Re: Comments of Antero Resources to the Proposed Amendments to 47 CSR, Series 63

Specific Comments to Proposed Amendments to 35 CSR, Series 8

2. Secondary Containment. 47 CSR, Series 63-10.2.

Figure 2-2: Separation of parcels at an oil production facility.

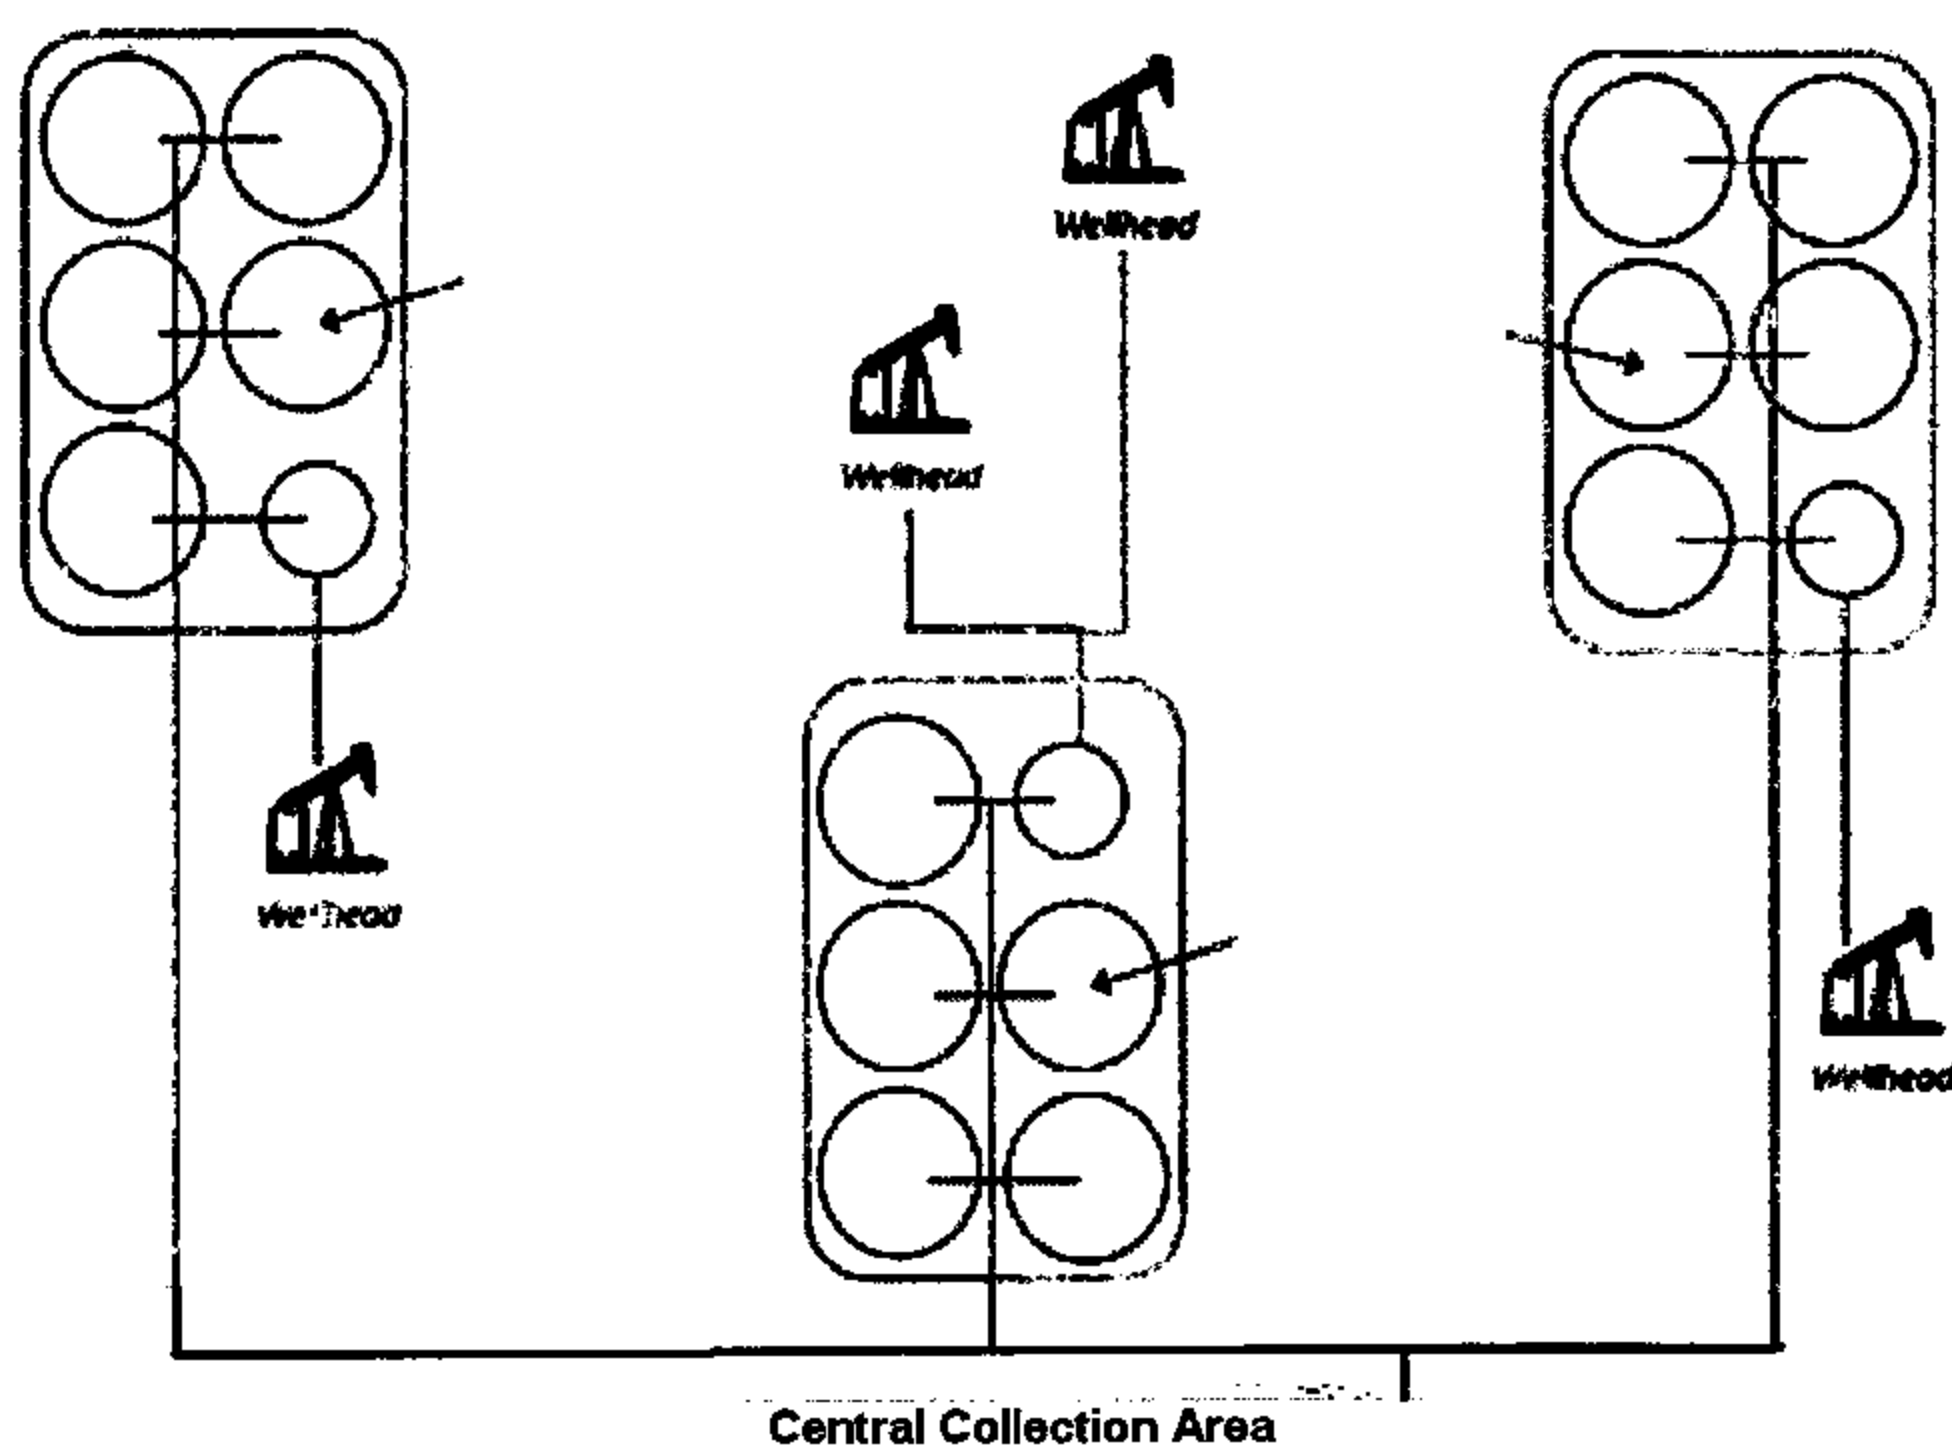
Determination: Given their geographic separation and the nature of the individual lease agreements, **each lease could be considered a separate facility**. Each tank battery stores a total aboveground capacity of oil greater than 1,320 U.S. gallons, so under such a scenario the operator must prepare and implement a separate SPCC Plan for each tank battery and its associated wellheads, flowlines, and equipment, as individual facilities. Any gathering lines that transport oil from these individual facilities into a centralized collection area involve the transportation of oil between facilities ("inter-facility") and are therefore UnotU within EPA jurisdiction. These "inter-facility" gathering lines do not need to be included in the SPCC Plans. In this example, the central collection area is a separate facility and may be subject to SPCC requirements. If the central collection area facility meets the SPCC rule applicability criteria, then a separate SPCC Plan must be developed.
